Revised Analyses of Decommissioning for the Reference Pressurized Water Reactor Power Station

Effects of Current Regulatory and Other Considerations on the
Financial Assurance Requirements of the Decommissioning Rule
and on Estimates of Occupational Radiation Exposure

Final Report

Figure 3.1 Schedule of activities during the four periods of DECON

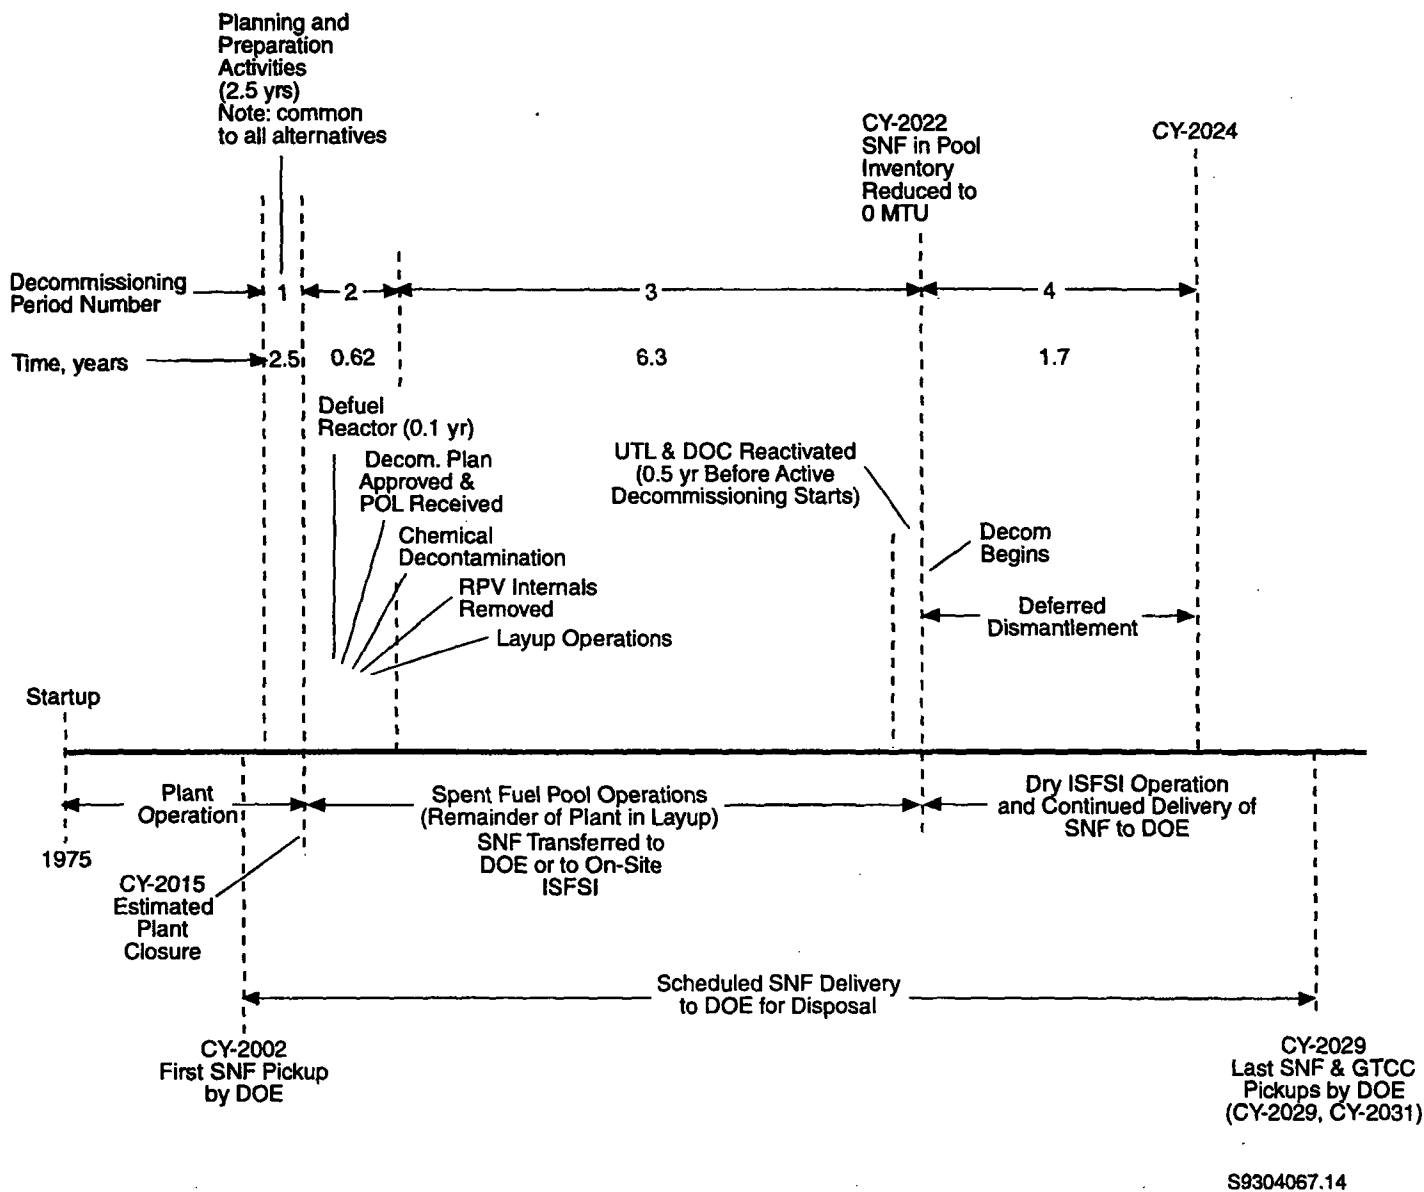
018-41 Comment: Figure 3.1: The On-Site ISFSI is a part of the decommissioning tasks. The ISFSI is provided to allow quick dismantling of the reactor portions of the facility. However, the ISFSI remains beyond the removal of the reactor facility. This ISFSI must also be decontaminated and dismantled, and is an unavoidable part of decommissioning this facility. This structure is developed solely as part of the decommissioning effort and cannot be charged to operations (as there is no operating plant). See general comment #1. Note that figure is not to scale.

Figure 3.2 Utility and DOC staff structure and staffing levels during pre-decommissioning: Period 1

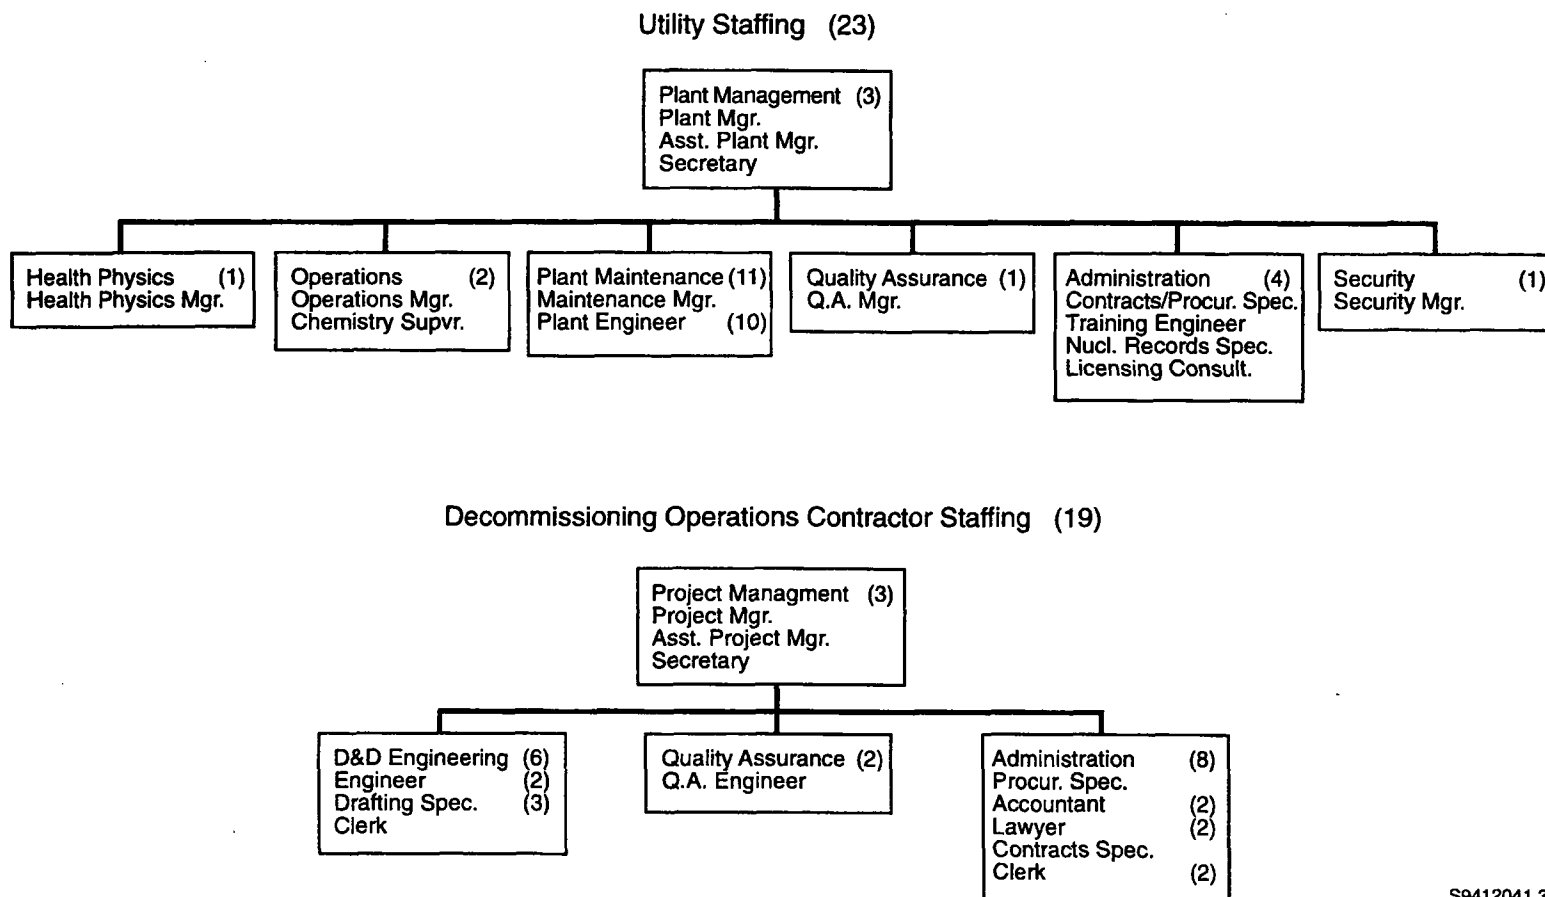
018-45 Comment: Figure 3.2: The utility staffing levels identified here (full-time) for Pre-Decommissioning do not match the decommissioning levels (part-time) identified in Table 3.2.

- Response:** The numbers of staff in each classification are given in the staffing diagrams, Figures 3.2, 3.4, 3.5, and 3.6. The numbers of person-years for each classification in each period are given in Table 3.2.

Figure 3.3 Schedule of activities during deactivation: Period 2

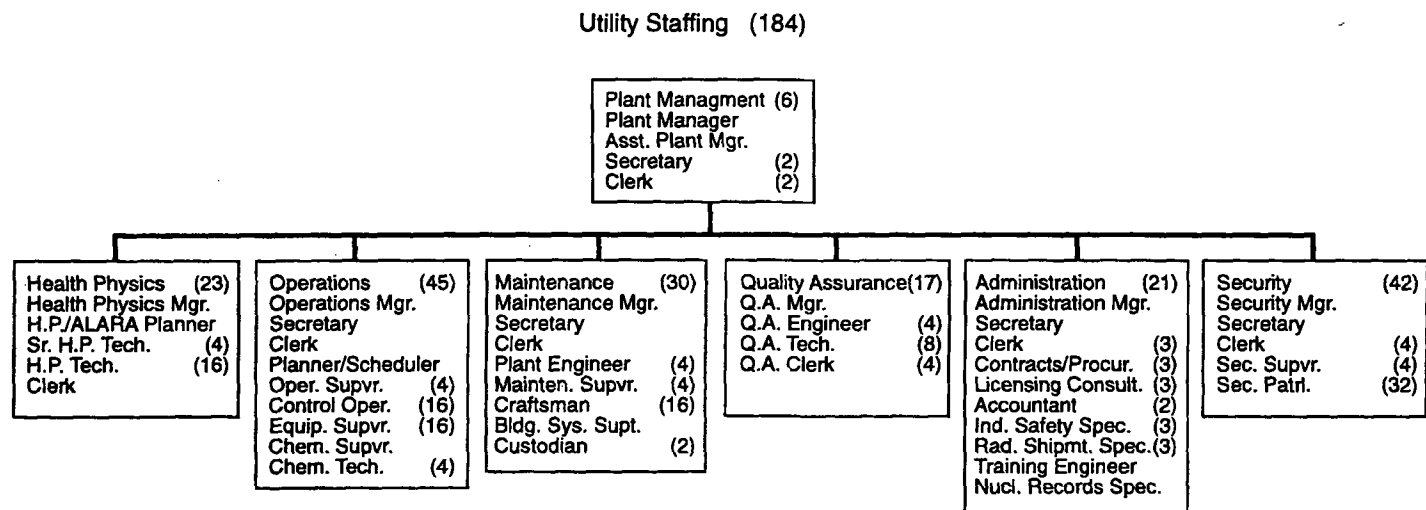
018-47 Comment: Figure 3.3: The third note ("Decon can start upon receipt of Decom. Plan approval") perpetuates the erroneous notion that decommissioning only means DECON. Decommissioning begins the moment the reactor is shut down for the final time. The existence of a plan, the decommissioning option used, and the source of funding are all irrelevant to the beginning of decommissioning from a Rate Commission viewpoint.

Response: No significant conflicts are expected. The schedule bars include the initial setup of the processes, then relatively short operating periods, followed by cleanup and removal of the processes. The schedule bars in Figure 3.3 have been modified to better illustrate these divisions of activities.

Response: The schedule and durations of the tasks represent the best judgement of the PNL analysts, and are based on detailed analyses of the individual tasks. Review of the schedule of activities given in Figure 3.3 shows that the periods of overlap are given to mobilization/demobilization, setup and testing, and cleanup and removal of the special systems and equipment used in the tasks. Without any knowledge of the circumstances at Yankee-Rowe, PNL cannot respond to the comment regarding the duration of cutting operations at Yankee-Rowe.

Figure 3.5 Utility staffing structure and levels during safe storage/SNF pool operations: Period 3

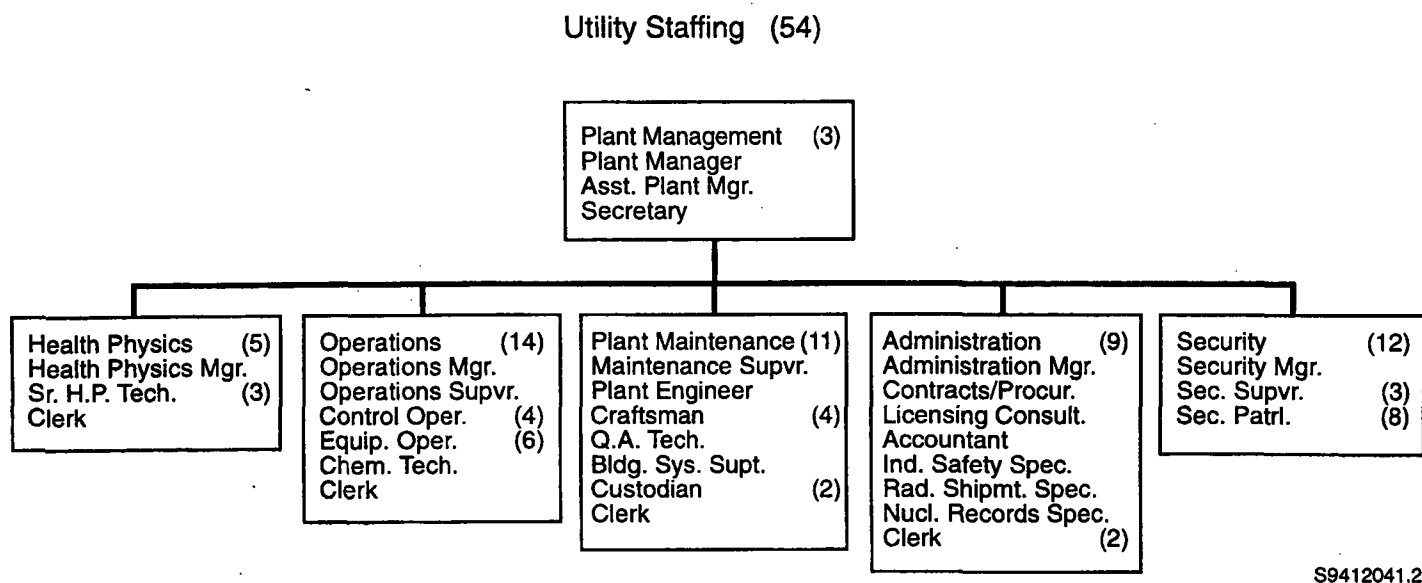
- 006-2 Comment: There are some inconsistencies in the staffing levels shown in the staff organizational structure charts. Figure 3.4 shows 23 persons in the Health Physics group; this should be 22, according to the breakdown. Figure 3.5 shows 13 in the Security group; this should be 12. Figure 3.6 shows 11 in the Utility Plant Operations group; this should be 12. That figure also shows 13 in the DOC D&D Engineering group; this should be 11.

018-49 Comment: Figure 3.5: The security staff identified (13 total) for Period 3 is not consistent with having spent fuel on site, with Period 2 (37 security staff), or with original studies (39 security staff). The movement of spent fuel to dry cask storage does not reduce site security staff requirements. This may be a result of arbitrarily assigning spent fuel security costs to "operations." See general comment #1.

The 90% / 10% allocation of utility staff occurs only during Period 3 (Figure 3.5). The size of the utility staff postulated represents the PNL analysts' best judgement as to how many and what kind of personnel would be required to maintain oversight of

Figure 3.6 Utility and DOC staff structures and staffing levels during dismantlement: Period 4

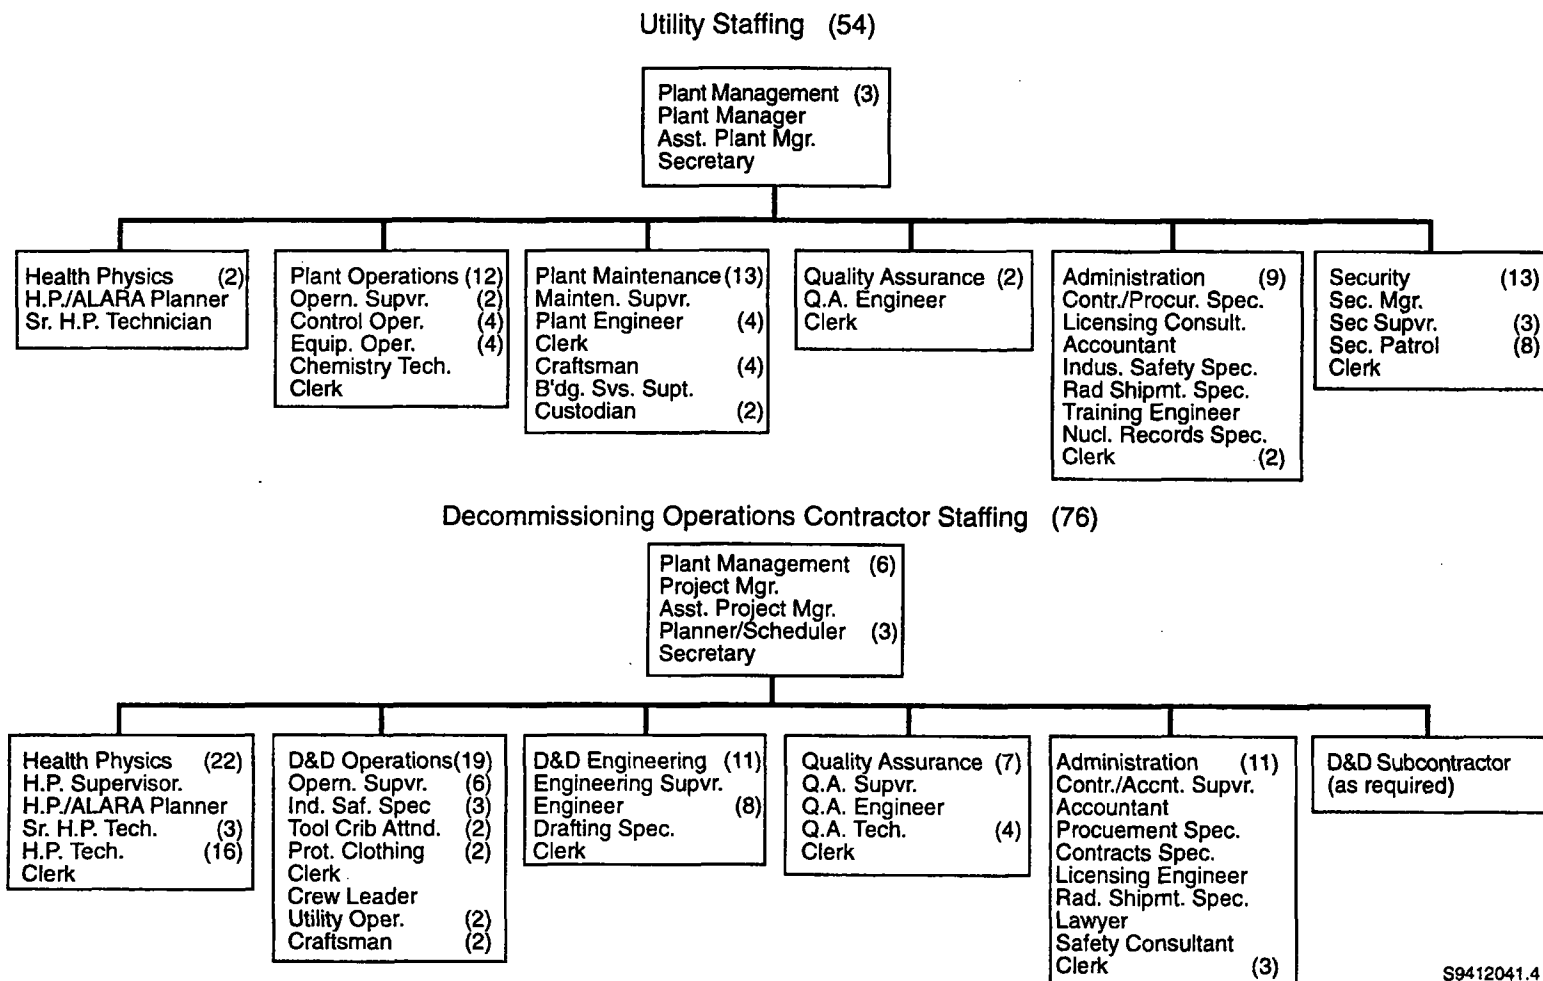
003-4 Comment: Page 3.12: PNL has assumed all work will be done on an 8-hour per day basis, two shifts per day. The utility and DOC staff shown in Figure 3.6 for Dismantlement does not indicate how many management personnel are dedicated for second shift operations. It is not reasonable to assume dismantling activities can be performed on second shift with no, or minimal second shift management.

018-51 Comment: Figure 3.6: The security staff identified (13 total) for Period 4 is not consistent with having spent fuel on site, with Period 2 (37 security staff), or with original studies (39 security staff). The movement of spent fuel to dry cask storage does not reduce site security staff requirements. This may be a result of arbitrarily assigning spent fuel security costs to "operations." See general comment #1.

Figure 3.7 Schedules and staffing for dismantlement activities in the Containment Building

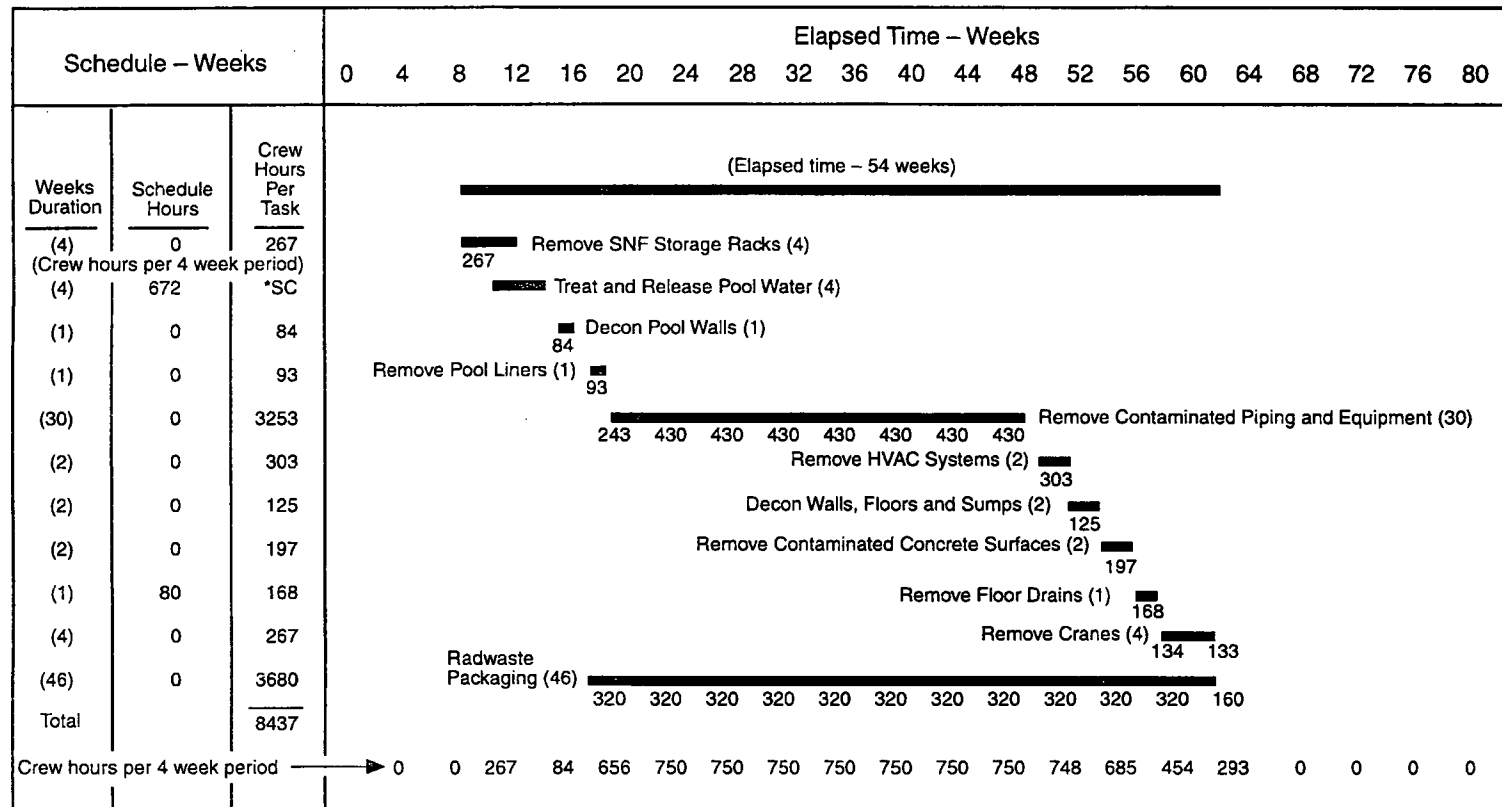
018-52 Comment: Figure 3.7: Apparent loading for Remove Floor Drains task should be 2, not 1.

018-66 Comment: Page 3.37, 2nd paragraph: Figure 3.7 indicates that the staff loading for bio shield removal is 6.5 people. Doses of 26 person-rem (13.4 pCi/gm or below) would therefore require additional staff to reduce dose rates to below NRC radiation dose limits. There is no indication that this has been done in this report.

Figure 3.8 Schedules and staffing for dismantlement activities in the Fuel Building

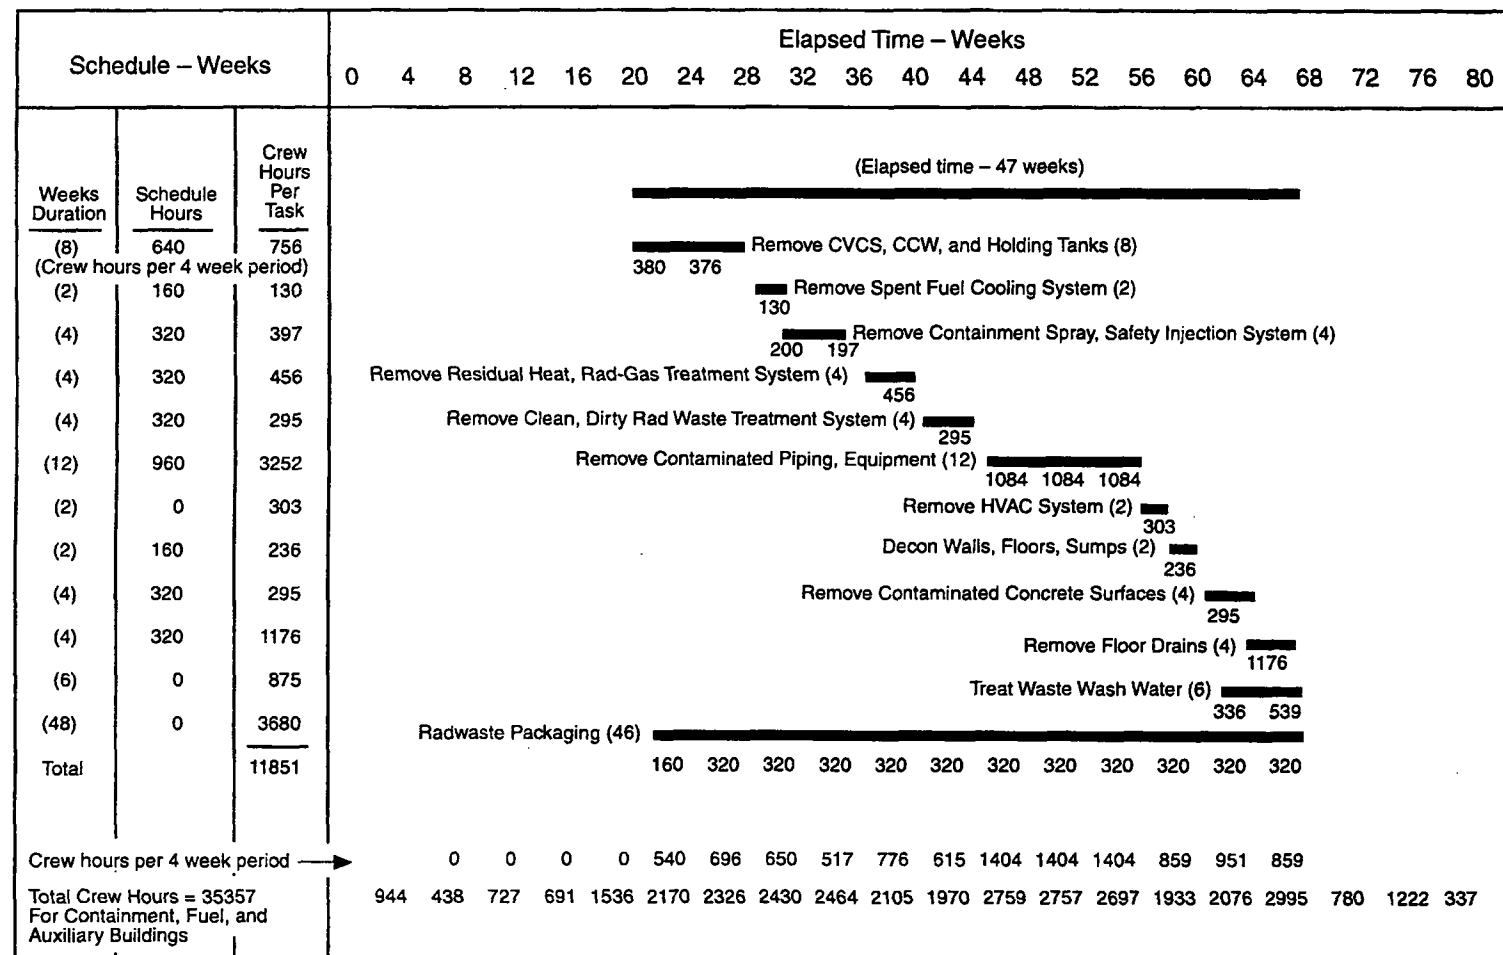
018-53 Comment: Figure 3.8: Elapsed time is 49 weeks, not 54 weeks (51 weeks if all tasks in line).

Figure C.2 Flow diagram for entering data into the CECP

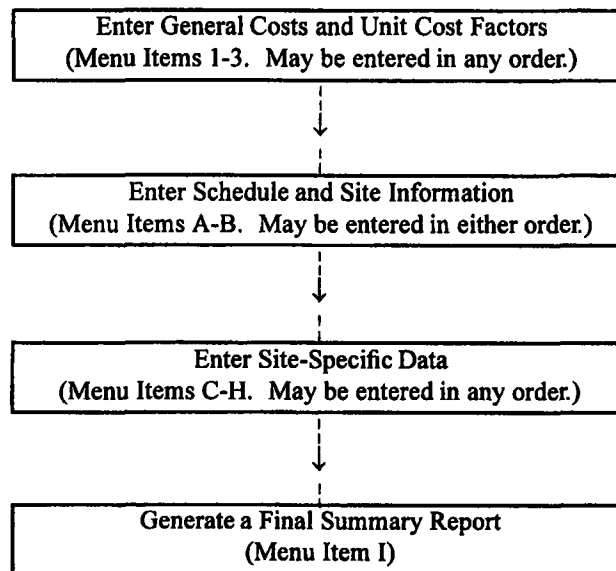
- 006-6 Comment: Section C restates verbatim much of NUREG/CR 6054. Consideration should be given to deleting this section from -5884; all discussion of the Cost Estimating Computer Program more appropriately belongs in 6054. If section C were deleted, the two volumes of NUREG/CR-5884 could be consolidated. (Furthermore, Figure 2.2 of 6054 is inconsistent with Figure C.2 of -5884 regarding sequence of data entry for menu items A, B, and C.)
